Determination 2011/055

Refusal to issue a code compliance certificate for 8-year-old alterations and additions to a house at 123A Marine Parade, Mount Maunganui

Figure 1: approximate plan (not to scale)

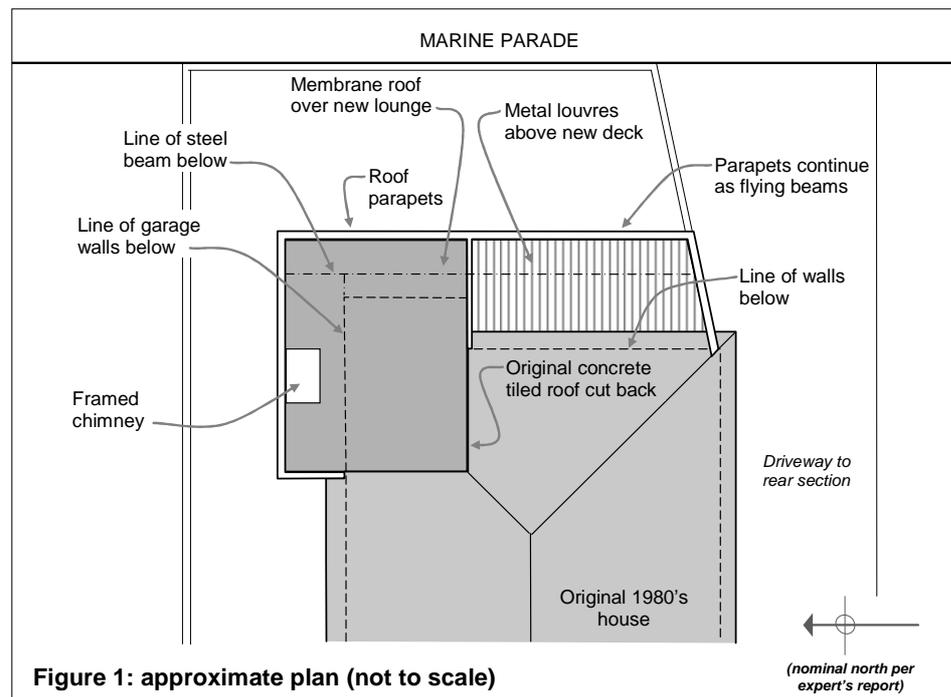
- the EIFS cladding beside the garage door extends below the paving level
- the high moisture level below the north lounge window indicates that the jamb to sill junction may not be weatherproof
- the flat membrane roof shows evidence of ponding
- the membrane capping to the chimney turns down under the coating, allowing moisture to drain behind the EIFS coating and possibly into the framing

- the recently installed parapet and beam cappings have flat tops and insufficient turndowns over the cladding, with high moisture levels in the framing below
- the cappings have over-flashings at the junctions with walls, which rely only on sealants for weatherproofing, with high moisture levels and decay apparent
- the extent of decay found in the limited testing indicates that parapets were leaking prior to capping installation in 2010, and the high moisture levels indicate that cappings continue to allow moisture into the untreated framing

- the flat tops of the balustrade lack cappings, with severe decay apparent
- the high moisture levels and severe decay indicate that balustrade to wall or column junctions have been allowing moisture entry for some time.
